Fire Safety Engineer (FSE) Workshop

13th June 2025 from 9.30 am to 12.30 pm
HQ SCDF City Campus 1A & 1B

Figure 9.2-1: Smoke Flow Diagram for Fire at 7th Storey Warehouse 7B

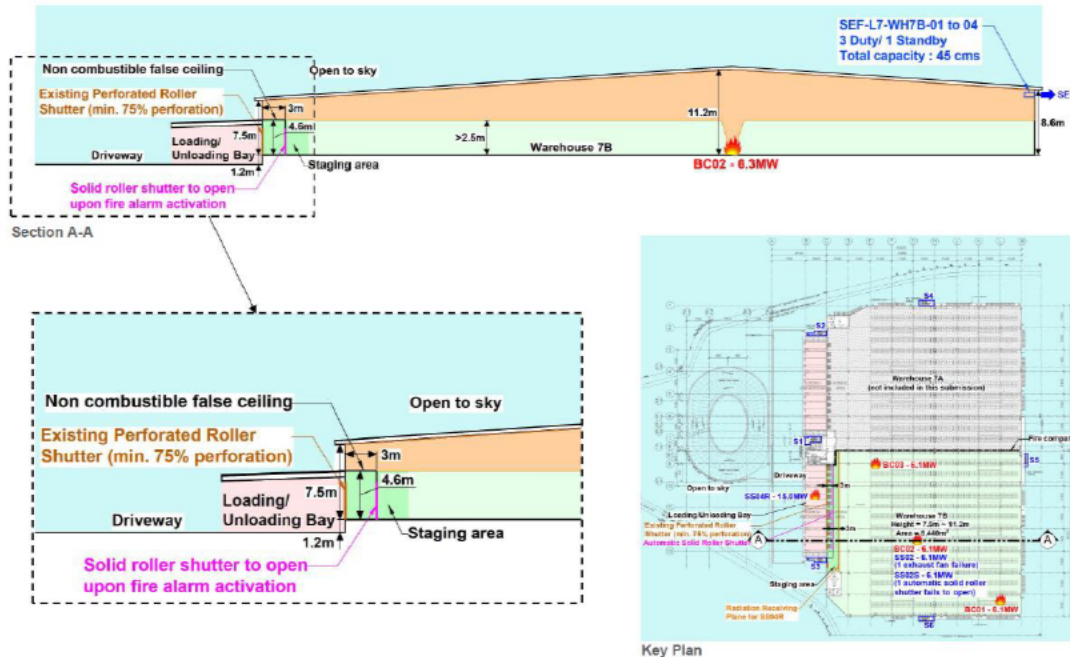
- The details of fire scenarios shall be indicated clearly in the marked-up layout/section view together with fire location in alignment with the tabulation of proposed fire scenario summary.

Minimum details needed to describe the fire are:	
(i)	Heat Release Rate (HRR)
(ii)	HRR per unit area and/or fire perimeter (nos. & dimension of burner)
(iii)	Fire growth rate
(iv)	Floor to floor or floor to ceiling height
(v)	Soot yield
(vi)	Combustible material
(vii)	2 nd ring sprinkler-controlled fire or other type of fire
(viii)	Axis-symmetric plume or spilled plume

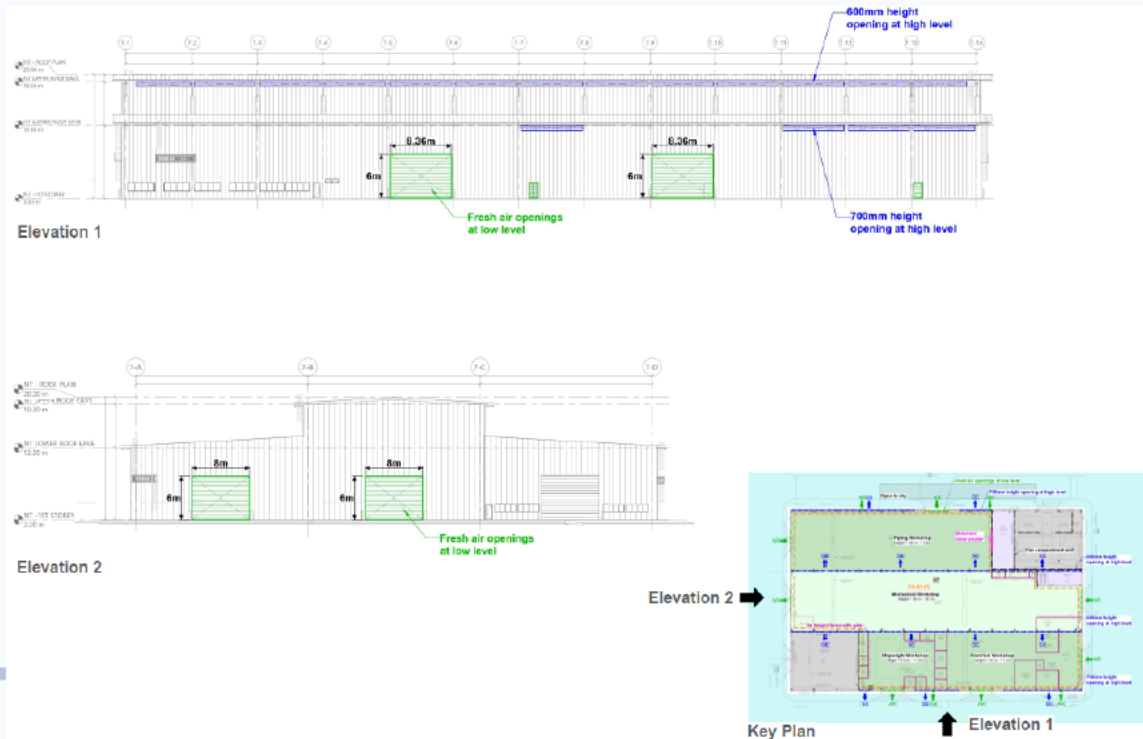
- In case of modeling a fire scenario with natural ventilation, the location and dimension of vent openings shall be indicated clearly in the layout too, together with the section view of fire location. E.g.

Figure 10.3-3: Heat Release Rate (HRR) Graph – BC01-6.1MW

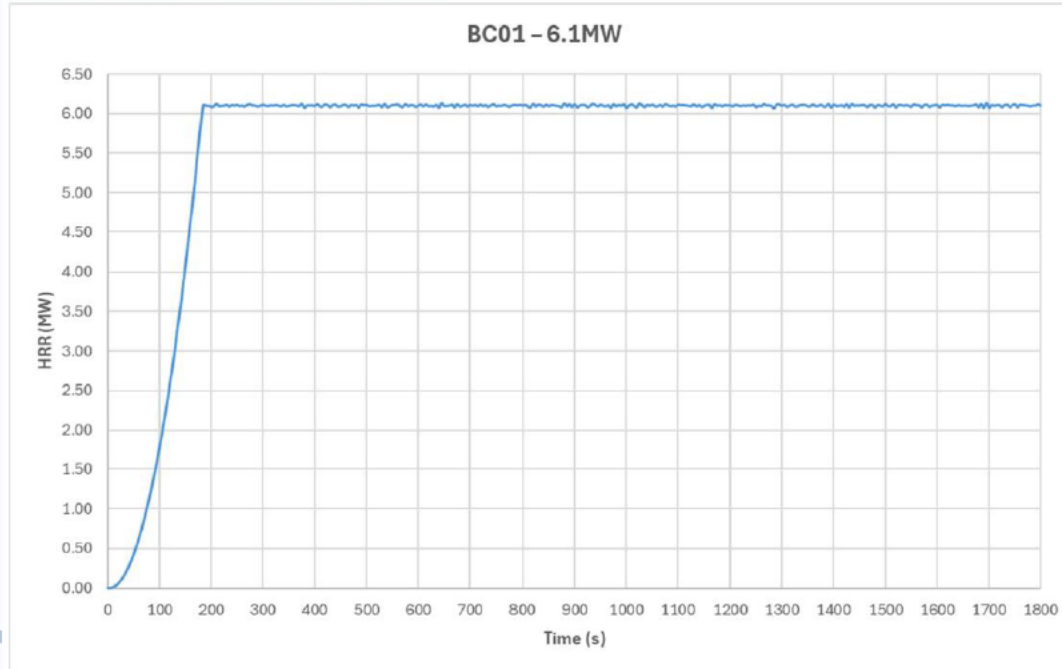
- FSE to document the overall graphic HRR output within the computational domain for each fire scenario to demonstrate fire size and fire growth rate captured in the simulation in alignment with your proposed fire scenario in the report. E.g.

Poor colour contrast (text against background)

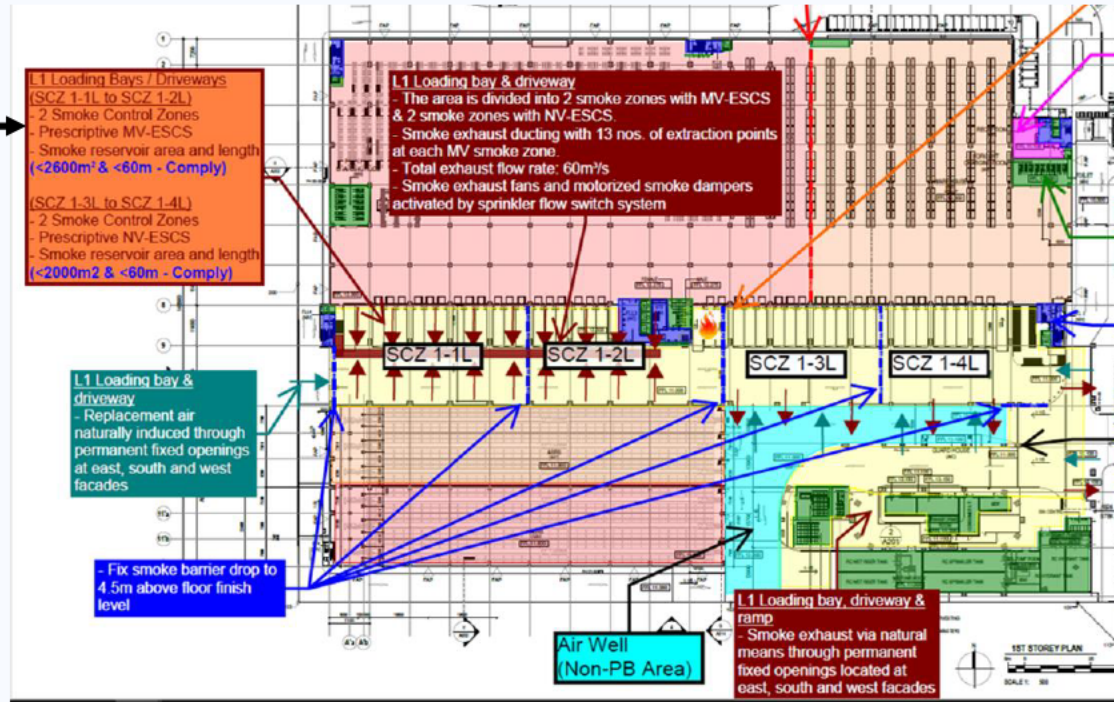
- FSE to ensure all text are legible with good presentation i.e. colours well contrasted.

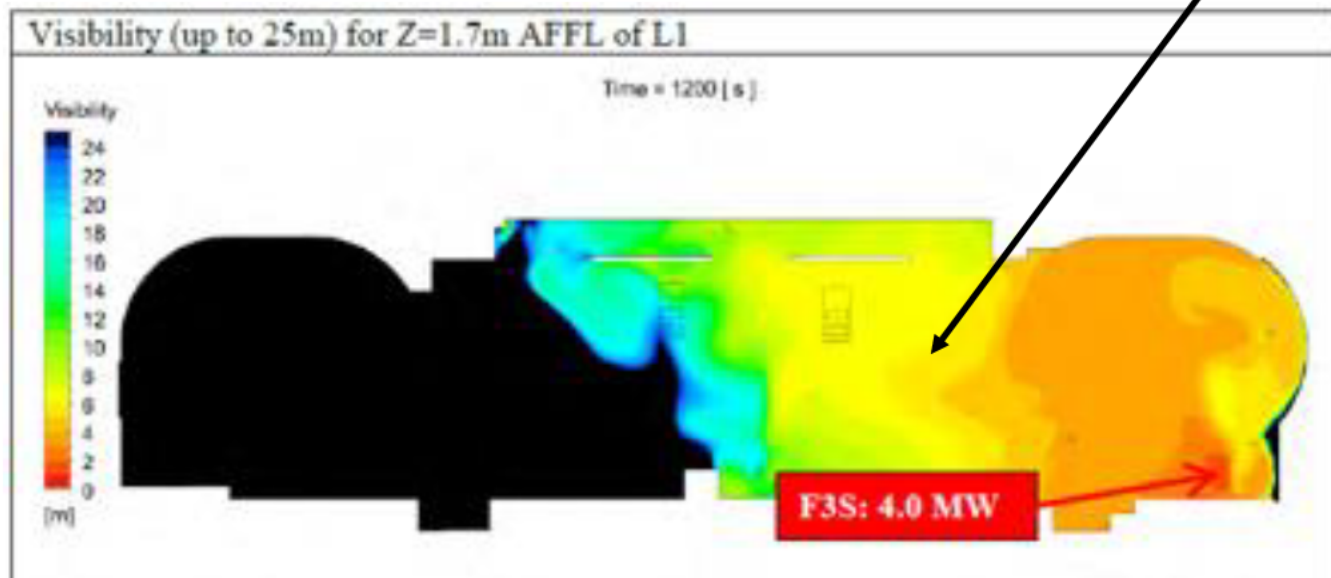
In the event 'visibility $\geq 25\text{m}$ ' criterion cannot be achieved for spaces beyond the maximum allowable 1000 m² smoke-logged area, FSEs can consider use of emergency illumination and subject to the following:

- (1) the illumination shall have **at least an average of 10.8 lux** along the path of egress measured at floor level during hot smoke test;
- (2) smoke temperature not more than 60°C and **visibility of at least 10 m** at 1.7 m AFFL; and
- (3) at least 1 viable route for firefighters within the smoke-logged area, where smoke temperature not more than 250°C and visibility of at least 5 m at 1.7 m AFFL.

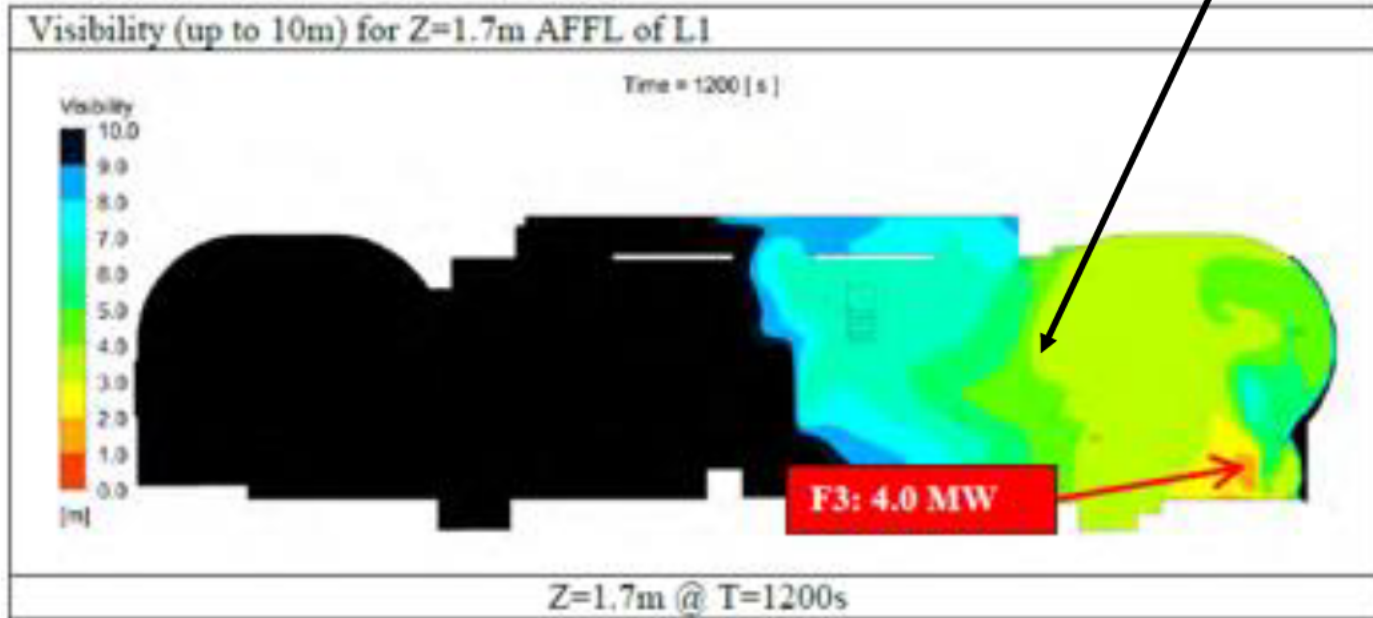
- Visibility output 2

To show smoke-logged area demarcation by visibility ≥ 10 m, **less than 1000 m²**.

Multiple Air Compressors on Ledge

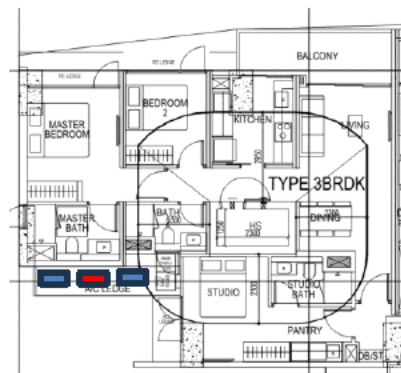
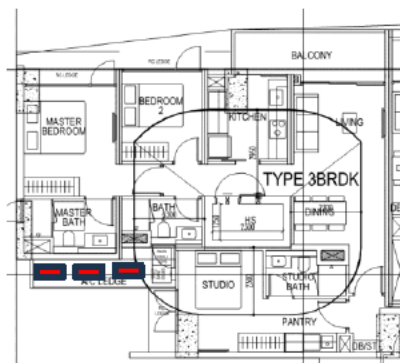
- FSEs to consider a multiple AC compressor fire scenario.
- Single AC compressor fire scenario can only be acceptable if FSEs provide justification that there is adequate AC separation to prevent fire spread between compressors. The AC layout must match fire engineering report.
